INITIATOR C. Gray
DATE 6/2/98
SERIAL NO. ER-004

ENGINEERING CHANGE REQUEST (ECR)

NEXT ASSEMBLY NO. D972609
CUSTOMER DRAWING NO. D972609
DRAWING TITLE L190 HAM SUPPORT BR
REVISION: FROM _____ TO _____

SP1 HAM ECR-D4

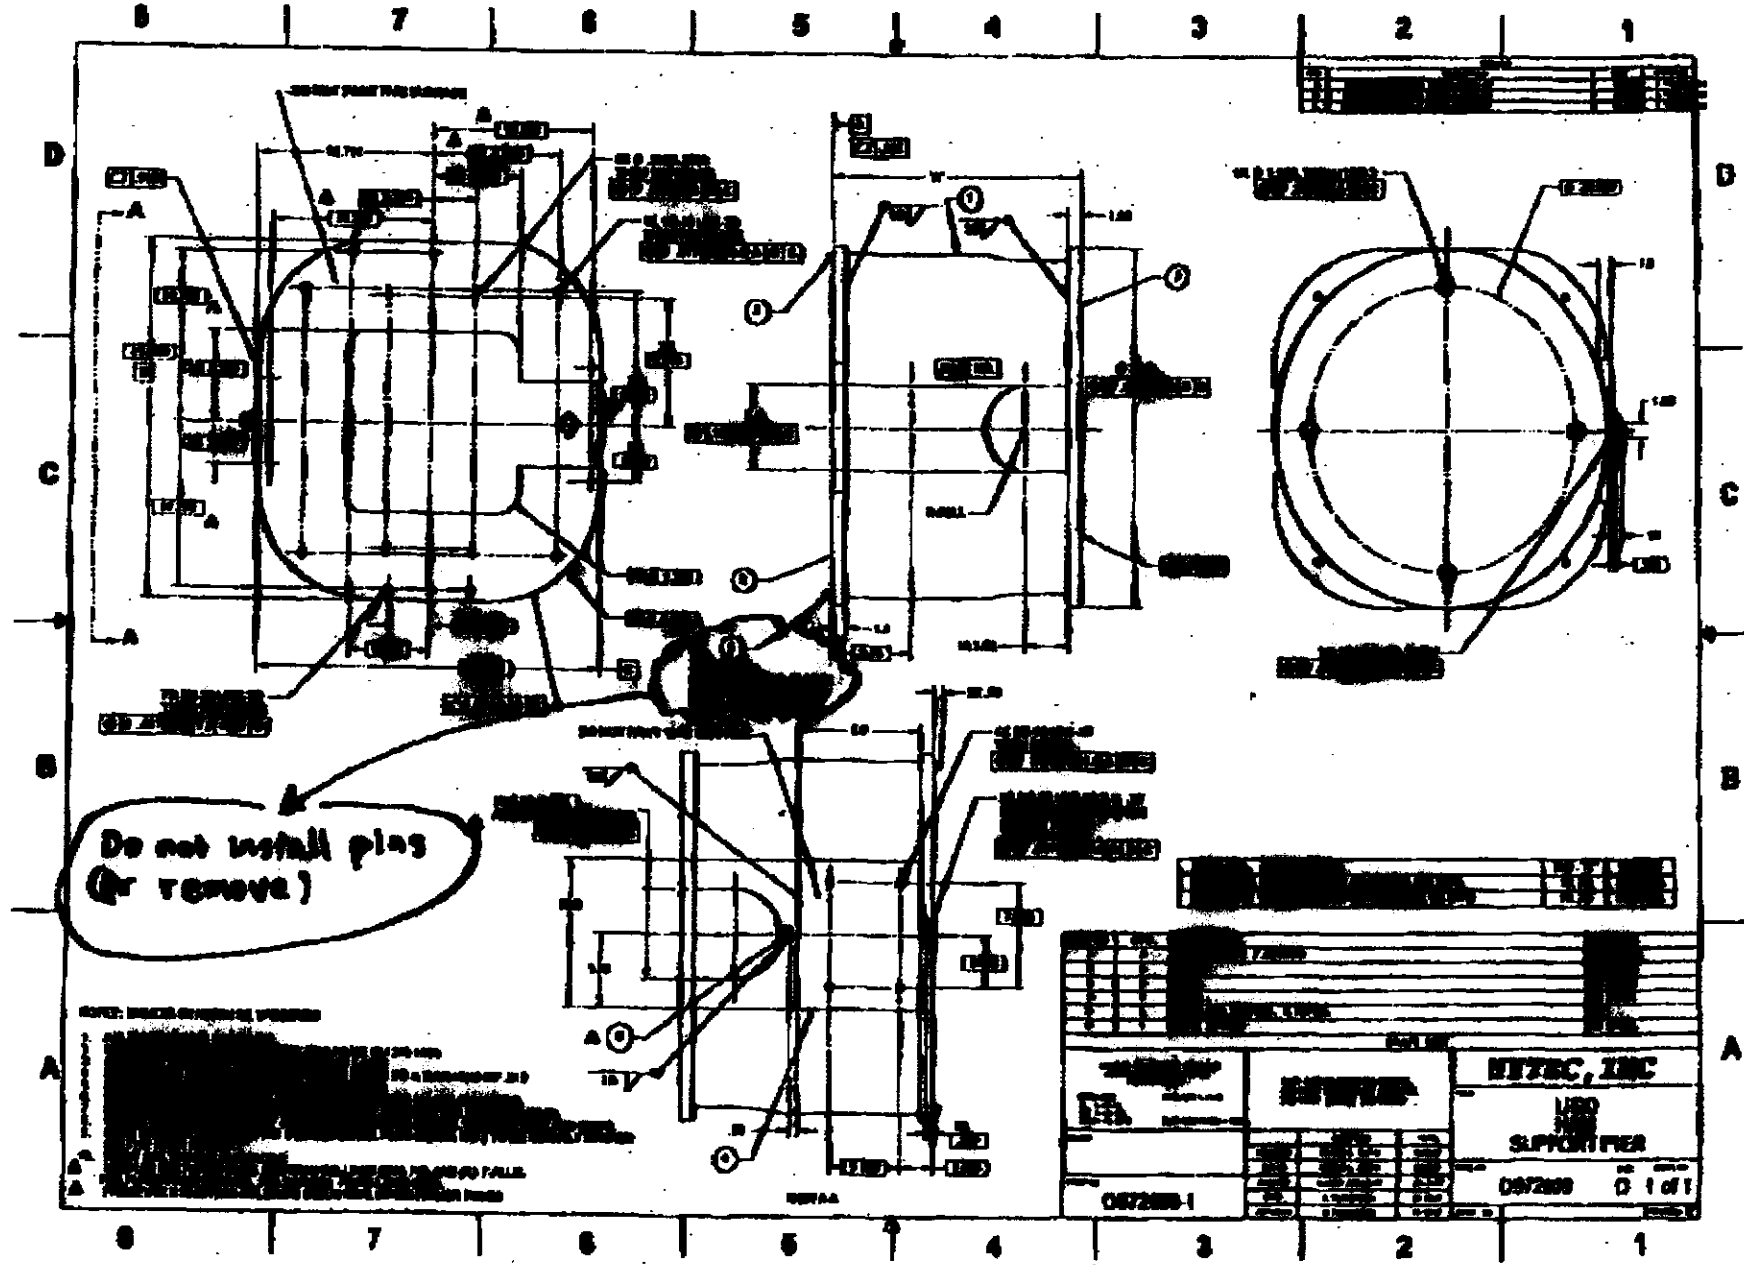
Remove both dorsal pins from Pier top plate.
(See drawing)

Allow freedom of movement of combiners (on actuator
stack and roller plate) on pier top plate.

Do not install pins
(or remove)
